**PREFERRED PROJECT REPORT
MAJOR PROJECT APPLICATION NO. 08_0234**

"RISE" BILAMBIL HEIGHTS

PREFERRED PROJECT REPORT

3.1 Department of Planning – 22 October 2009

A-MP-01-18F

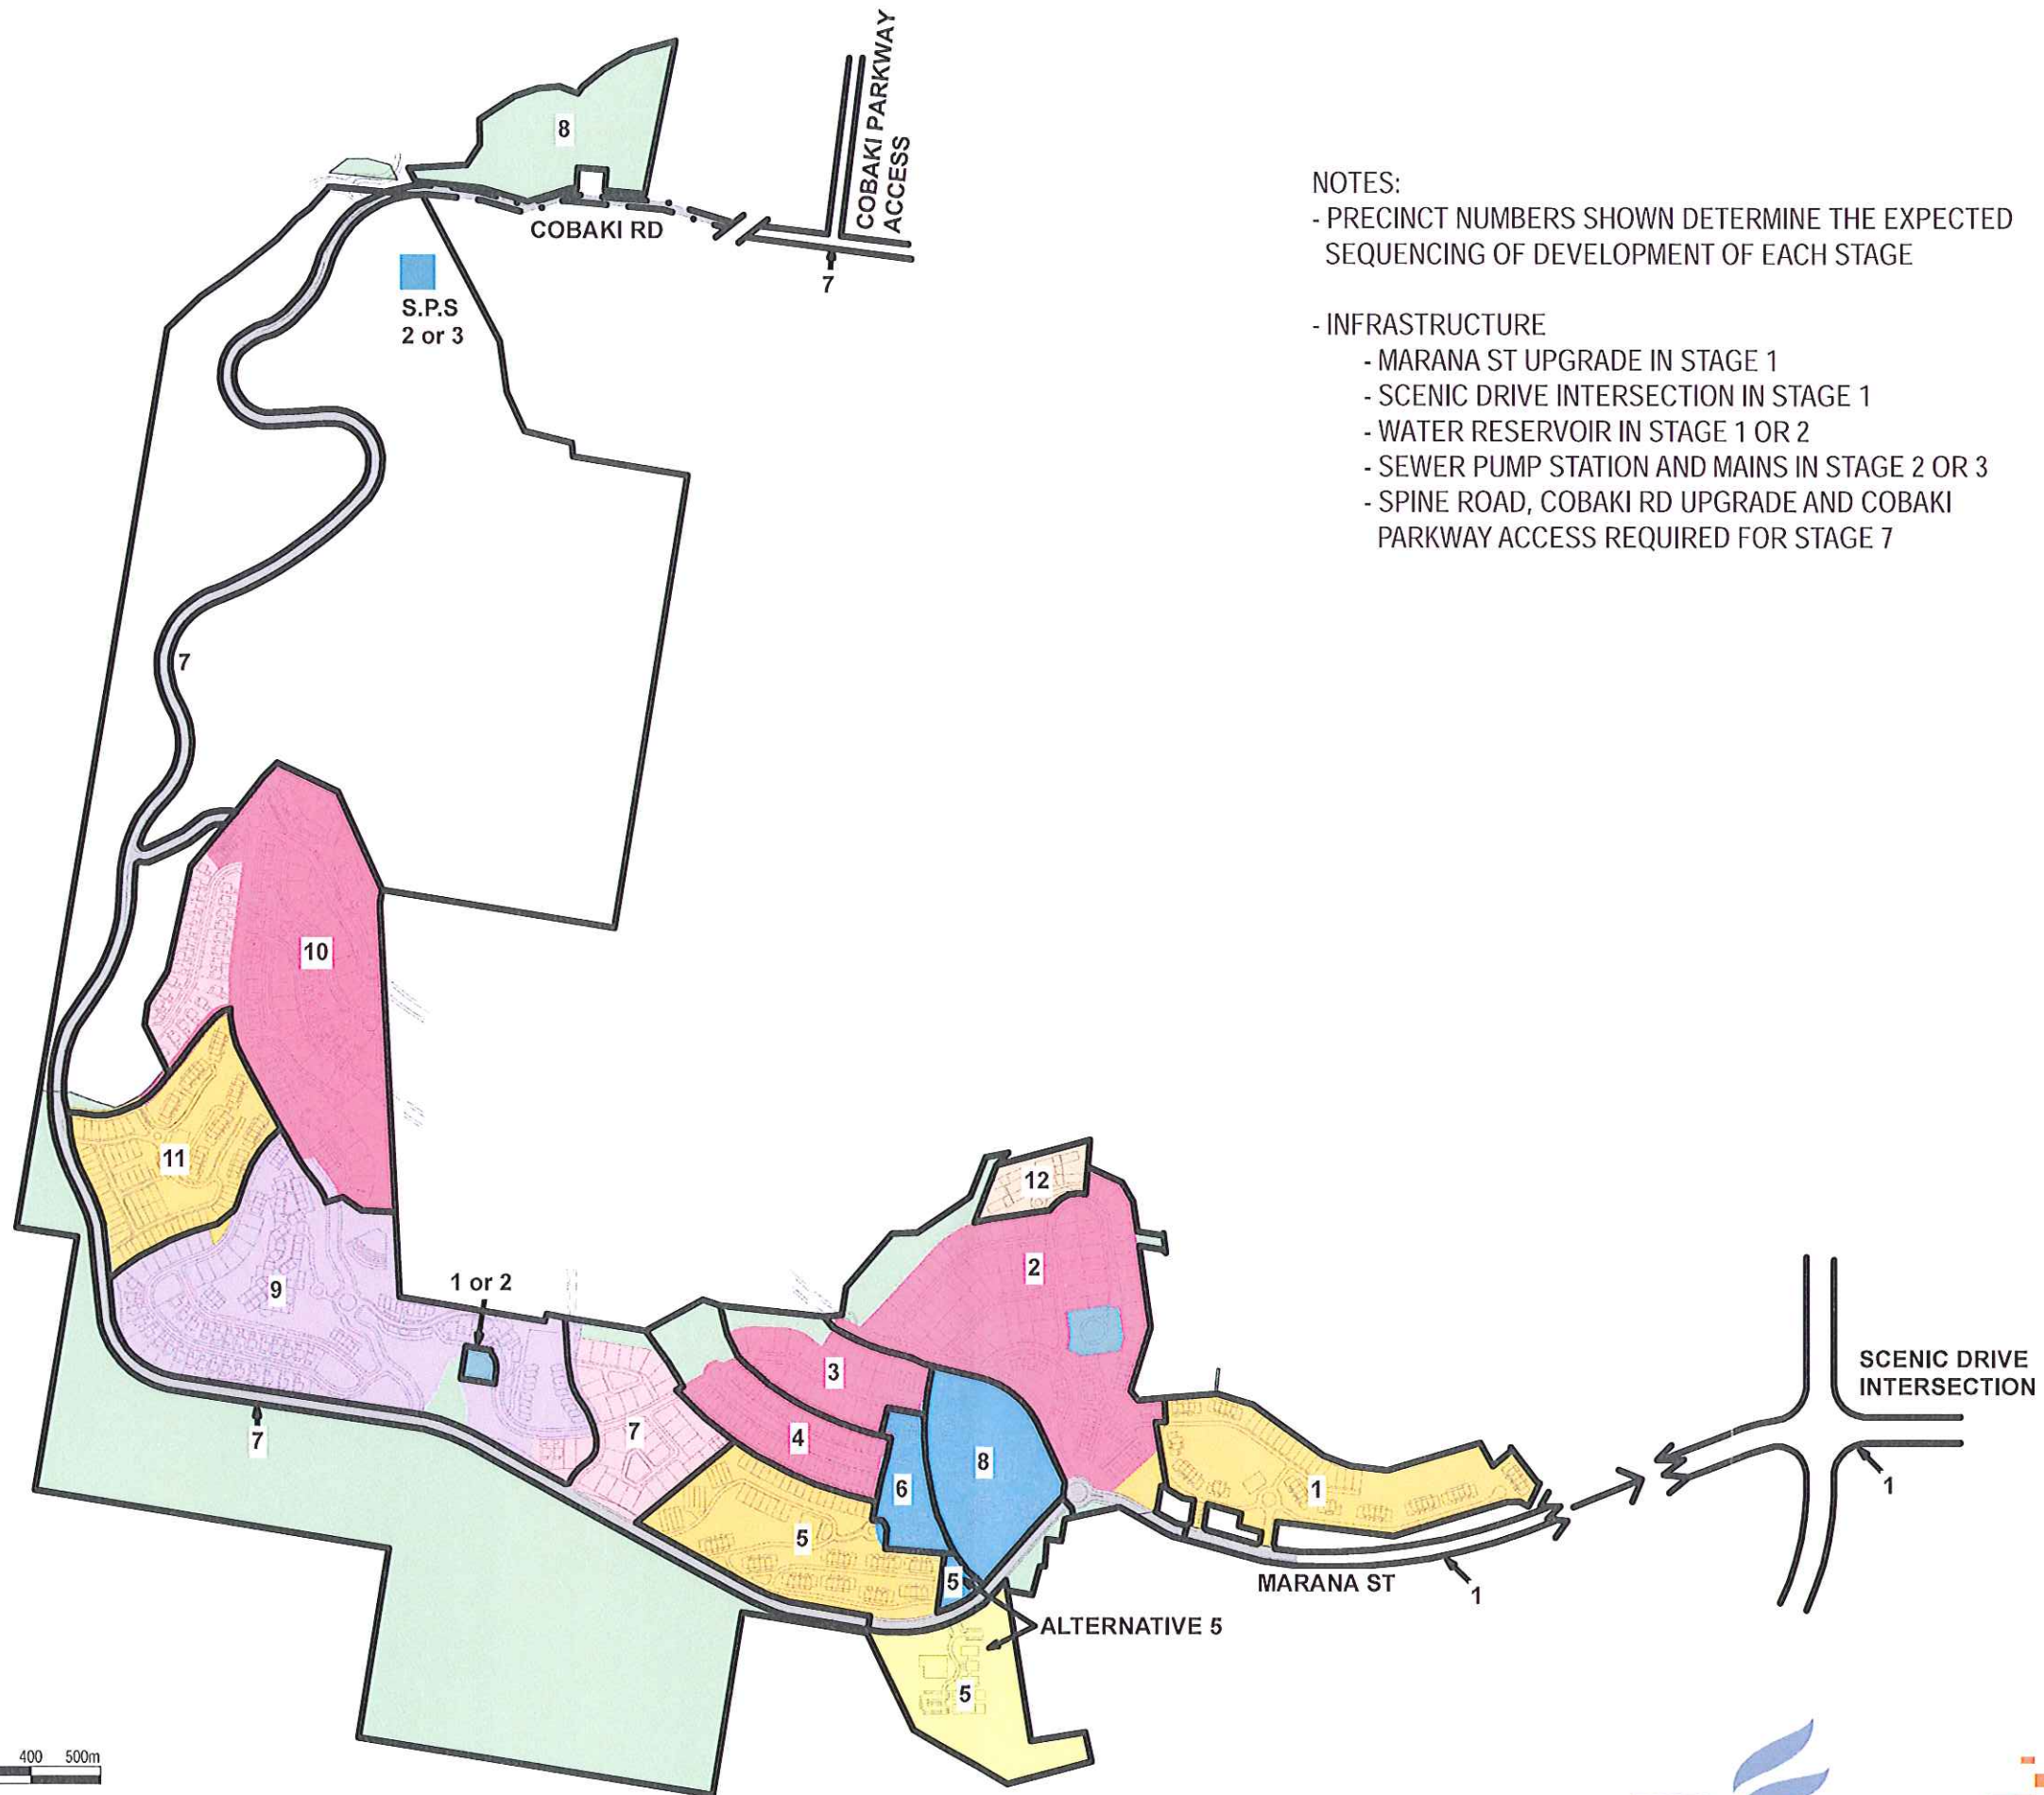
<p>3. Connectivity</p> <p>The Concept currently provides two future road connections to the remaining Bilambil Heights urban release area adjoining the site directly to the north. Tweed Shire Council (Council) has advised that 1 connection should be provided every 200m. At least two additional future road connections should be provided north of Precinct L to ensure permeability with the remaining urban release area.</p>	<p>The amended Precinct Plan at Annexure A (Reference A-MP-01-18F, ML Design, 03.12.09) and all other attached revised plans show two additional road connections to the adjoining "Tietzel" land which is located to the east of the RISE site.</p> <p>This addition now allows for four (4) road connections to the future urban land adjoining the RISE site to the east.</p> <p>Land has now been allocated in the Concept Plan for these two new roads to be constructed in the future by others should they be required.</p>

Amendments to the Precinct Plan (and other annexed plans) have been made to provide two additional road connections to the adjoining land to the east of the "RISE" site.

The amended Precinct Plan at **Annexure A** (Reference A-MP-01-18F, ML Design 03.12.09) shows the additional proposed road connections.

SITE PLANS - BUILDING HEIGHTS SUMMARY

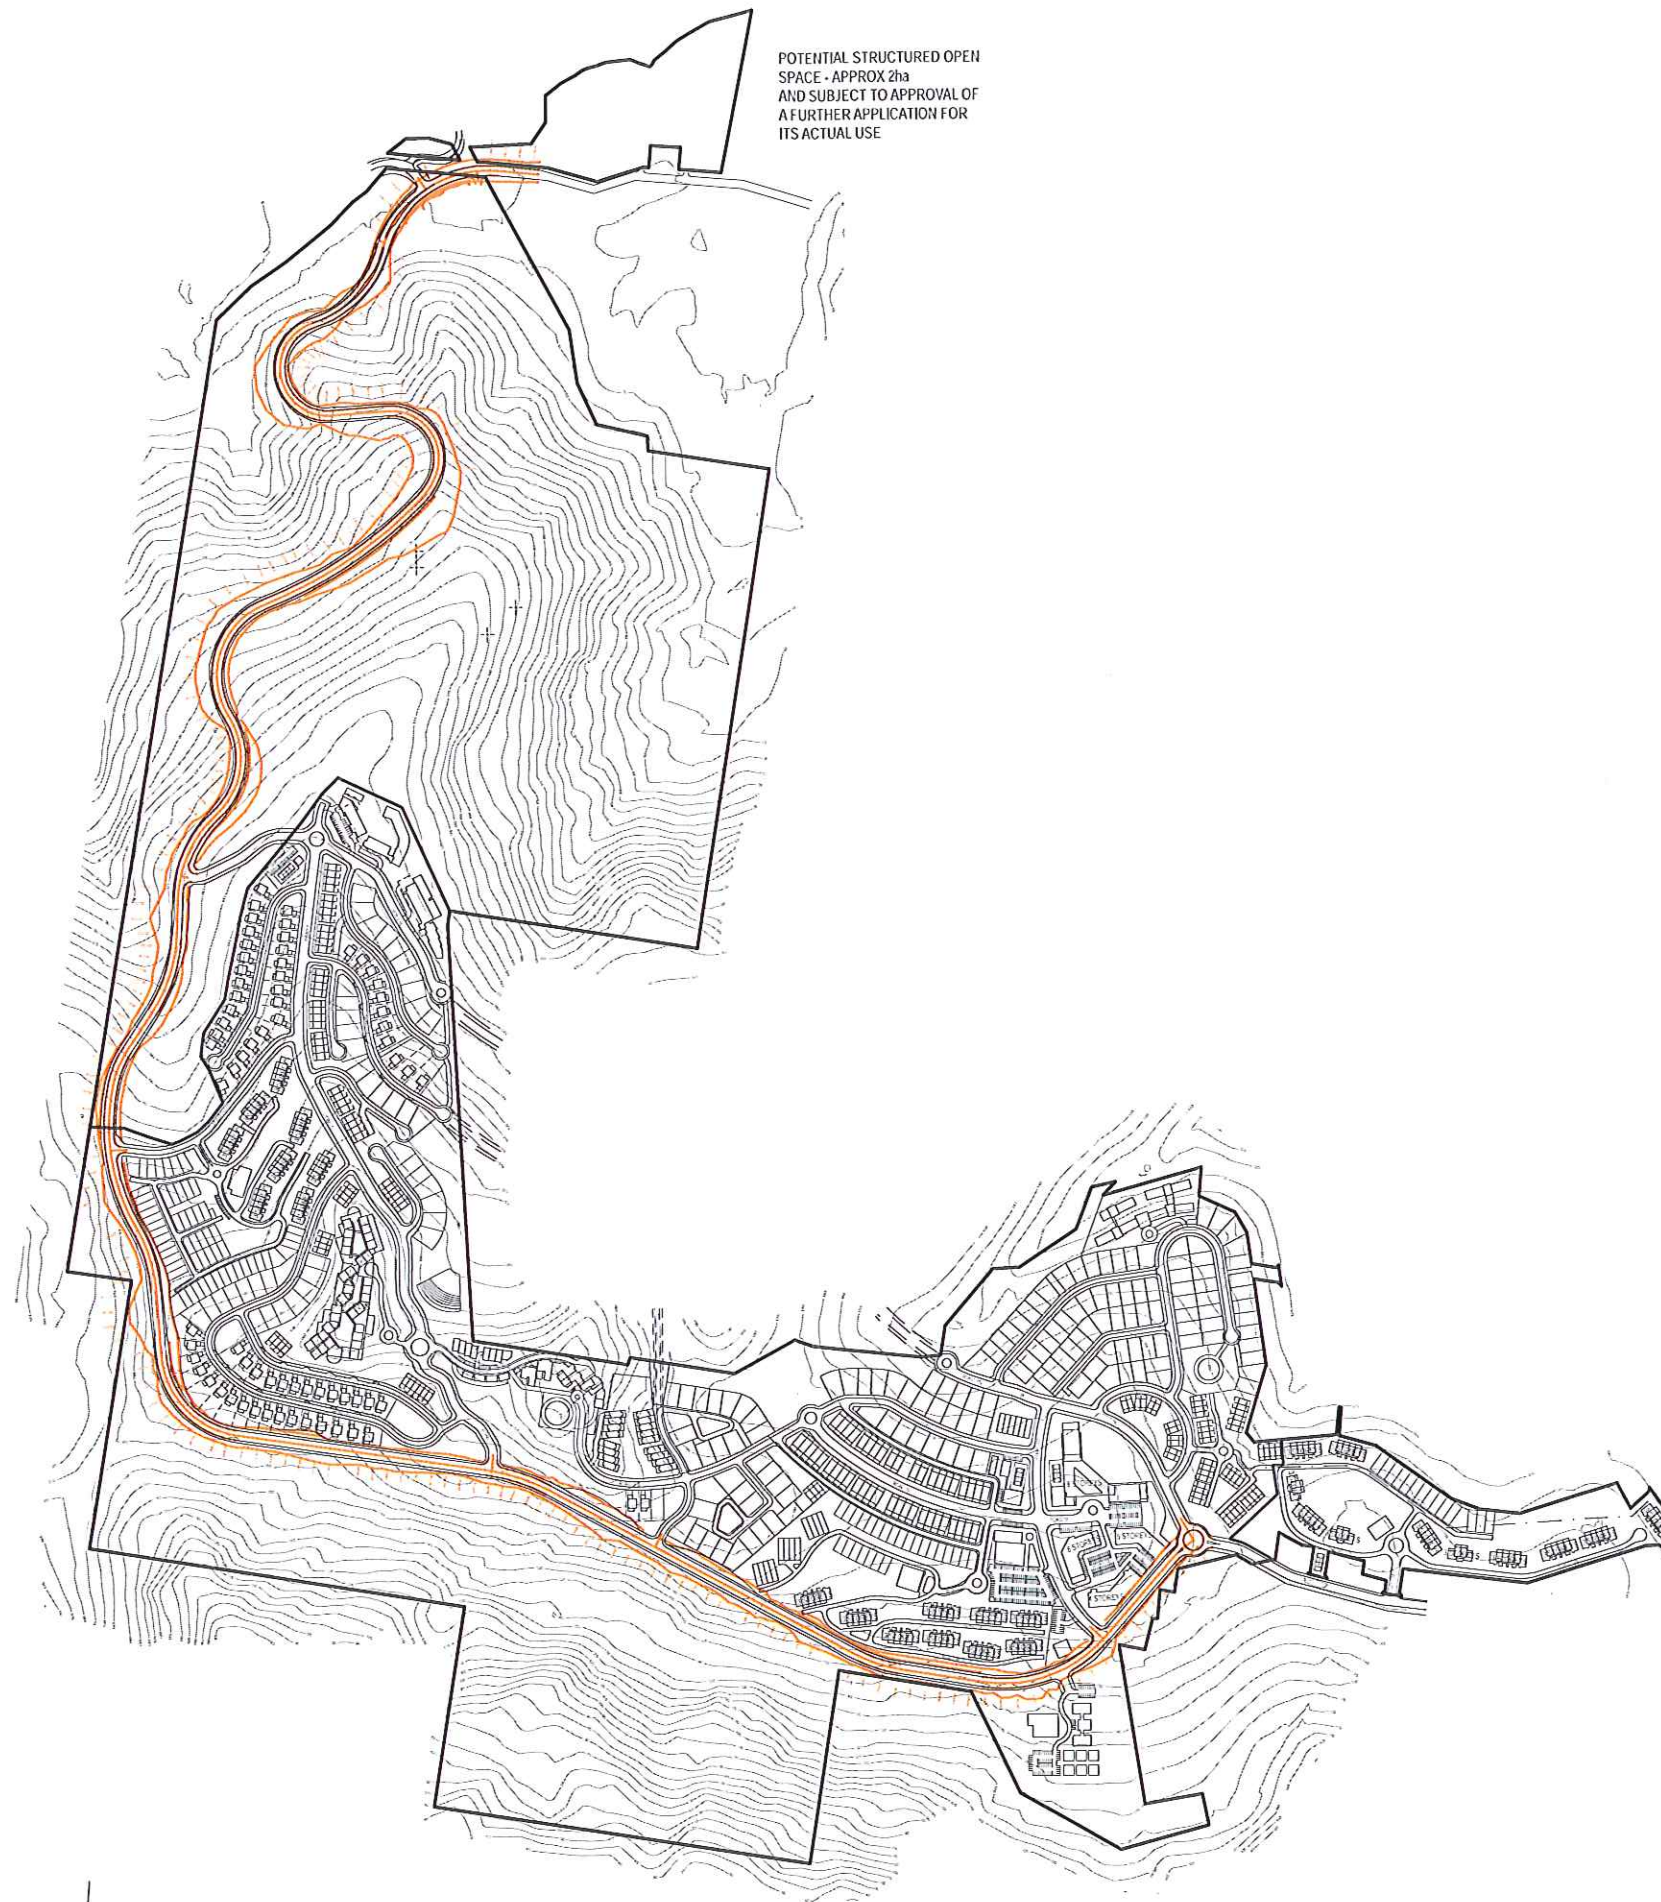
<p>4. Building Heights</p> <p>The proposed 6-8 storey heights in Precincts A and L are inconsistent with surrounding area and the likely future context and neighbourhood character. Insufficient planning justification has been provided to support this part of the proposal.</p> <p>All building heights should be given in metres (RL's to AHD).</p>	<p>The attached amended Building Height Plan (Reference A-MP-01-20F, ML Design, 03.12.09) shows proposed amended building heights, including proposed maximum building heights in metres for buildings above three stories. The building heights for buildings previously over three stories have generally been reduced to a maximum of four stories other than one five storey building and one six storey building in the Town Centre (Precinct A) and this has not resulted in any reduction in yield. As indicated on the attached amended Building Heights Plan, the area of buildings exceeding three storeys is very small and the vast majority of buildings comply with the three storey statutory height limit. We submit that the amended building heights strike a reasonable balance between the concerns raised by Council and the Department and the need to achieve a sustainable and viable development.</p> <p>It should be noted that any further reduction in building heights will impact on the density of the project, particularly in the town centres, which will have the economic affect of making the proposed retail and commercial components of the project commercially unviable and unsustainable.</p>

<p>Heights & Views</p> <ul style="list-style-type: none"> Application has not satisfactorily demonstrated the public benefit of the proposed increase in height and accordingly it is recommended existing height limits are retained. Large building footprints in Precinct B have a 3 storey height limit. Future applications will need to address retained amenity and opportunities for view sharing for existing residential properties. 	<p>See comments above relating to revised building heights and nil visual impacts.</p> <p>Noted.</p>
<p>Ecology</p> <ul style="list-style-type: none"> Site is of high conservation value, containing Lowland Rainforest (EEC). Subject to a current Land and Environment Court case (DECC v Rawson) for removal of threatened flora species. Impact assessment should consider cumulative impacts including past damage to threatened species. Impact assessment should consider construction and occupation impacts on threatened species. Development footprint will significantly impact on threatened species and ecological communities due to the current location of Spine Road and Precinct J that will affect areas of EEC. The ecology assessment is flawed: inaccurate referencing and inconsistent in parts, fauna surveys only taken outside the development footprint, does not assess previous illegal removal of native vegetation, south east portion of the site although has Camphor Laurel could include EEC. Loss of E2 zoning from current and draft Local Environmental Plan. Landscape Concept Plan misleading as it shows remaining area (referred to as Stage 2) as bushland. 	<p>Noted. There will be a net gain of 1.58ha of Lowland rainforest vegetation on the subject site. Furthermore, all existing areas of Lowland rainforest on the site will be rehabilitated.</p> <p>The Court case relating to the clearing has been finalised and no adverse findings have been made against the landowner and proponent of this Concept Plan.</p> <p>The status of significant plant occurrence can only be assessed on what is present at the time of the assessment.</p> <p>This will form part of the individual Development Applications per Stage or Precinct in the future.</p> <p>Precinct J has now been deleted.</p> <p>The Spine Road location and detailed layout has been resolved with and accepted by the Tweed Council's Engineering Department.</p> <p>The impact assessment has considered all potential direct and indirect impacts and was conducted after the damage had occurred.</p> <p>No comment.</p> <p>The EA Design Landscape Open Space Concept Plan Report which forms part of the application is only an indicative report to show the proposed landscape works for the project. It is not intended to detail what may exist or occur in Stage 2 of the site, and Stage 2 of the site does not form part of this application.</p>

The amended Building Heights Plan at **Annexure C** (Reference A-MP-01-20F – ML Design, 03.12.09) shows the proposed amended building heights plus the proposed maximum building heights in metres above existing ground level for buildings above three storeys.
